**NPCC Reliability Reference Directory #7
Special Protection Systems
Draft Sept 27, 2012**

ISO-NE Comments and TFSP Responses

**NPCC
Regional Reliability Reference Directory # 7
Special Protection Systems**

Task Force on System Protection Revision Review Record
December 27, 2007
Draft Sept 27, 2012
For Open Process Review

FLOW CHART FOR THE REVIEW OF NEW ~~OR MODIFIED~~
SPECIAL PROTECTION SYSTEMS (SPS) OR THE MODIFICATION OF AN
EXISTING SPS

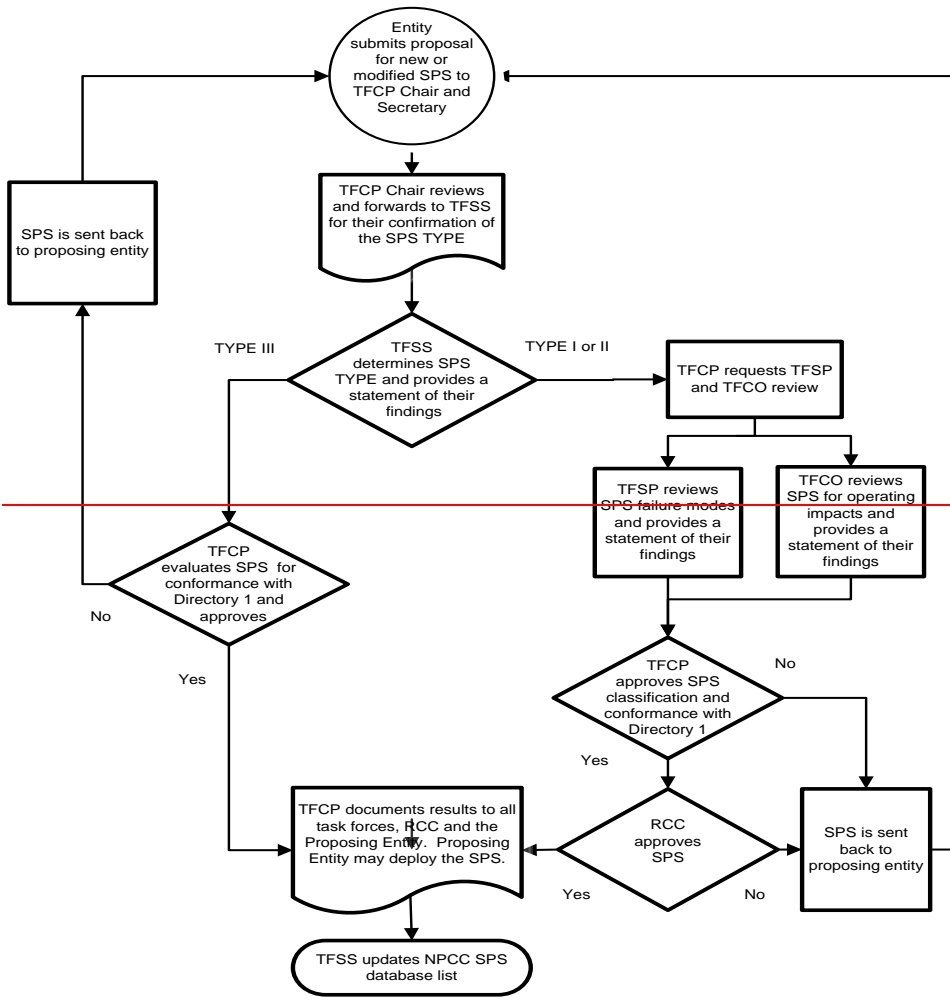
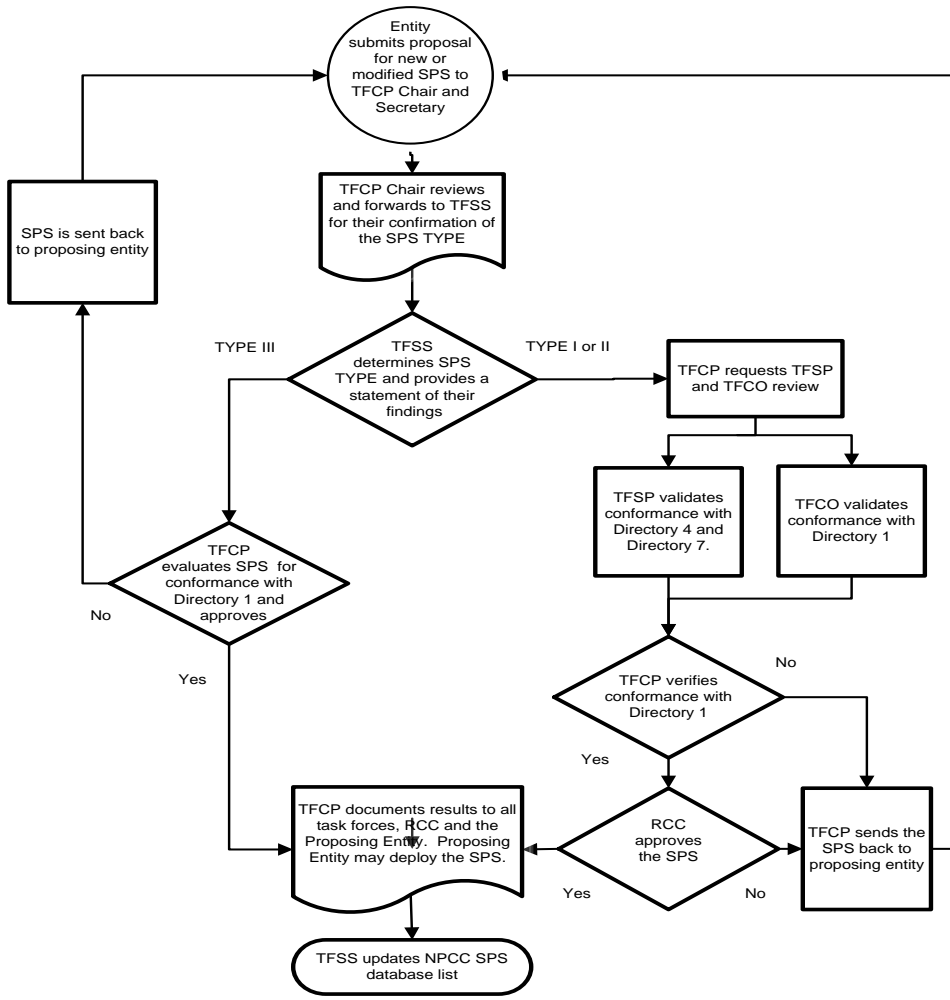
Comment [r16]: Suggest deleting this text – it is not clear under which grounds a rejection could take place. Please edit chart to match this wording – the remand of the SPS goes to the TFCP

Comment [r21]: Please update charts to match wording
